Addendum / Addenda

No./N^o
2

Project Description / Description de projet VIC - RE-Roof		
Solicitation No./ No de sollicitation 15-22102	Project No./N ^o de projet	W.O. No./N ^o d'ordre de travail
Project Engineer / Ingénieur de projet Clyde Donnelly		Date October 19, 2015
<p>Notice: This addendum shall form part of the tender documents and all conditions shall apply and be read in conjunction with the original plans and specifications.</p>		<p>Nota: Cet addenda fait partie intégrale des dossiers d'appel d'offres; toutes les conditions énoncées doivent être lues et appliquées en conjonction avec les plans et les devis originaux.</p>

TITLE: SITE VISIT MINUTES - Victoria Re- Roof

Steep Slope Cut
Stucco Wall Detail

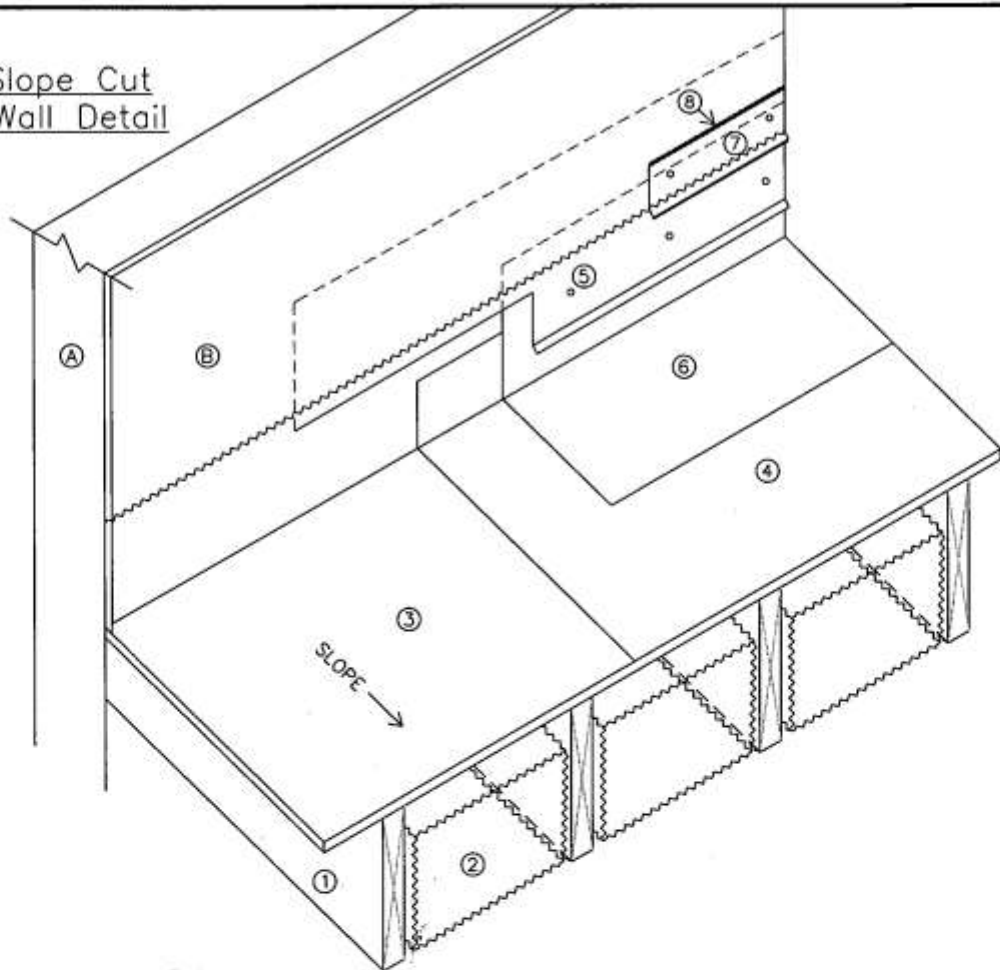
Drawing Number A-08 " Steep slope cut stucco wall detail"

.10 Cut existing stucco wall finishes at roof wall transitions and remove existing metal flashing and; supply and install new two piece metal flashing wall detail as per attached Surface Reglet Flashing Stucco Wall Detail A-08.

NOTE: Attachment: Surface Reglet Flashing Stucco Wall Detail A-08.

1. Wood Rafter
2. Batt Insulation (62mm (2½") Lower Than Bottom of Plywood Deck)
3. 15.9mm (¾") Sheathing On Existing Deck
4. Underlay Membrane
5. Metal Flashing
6. Wall Base Flashing(Under Stucco Wall Finish)
7. Surface Reglet Flashing Pinned to Wall at 200mm(8") O/C Through Stucco
- B. Approved Caulking

- A. Existing Wall
- B. Existing Stucco(Saw Cut 250mm (10") Above Roof Surface)
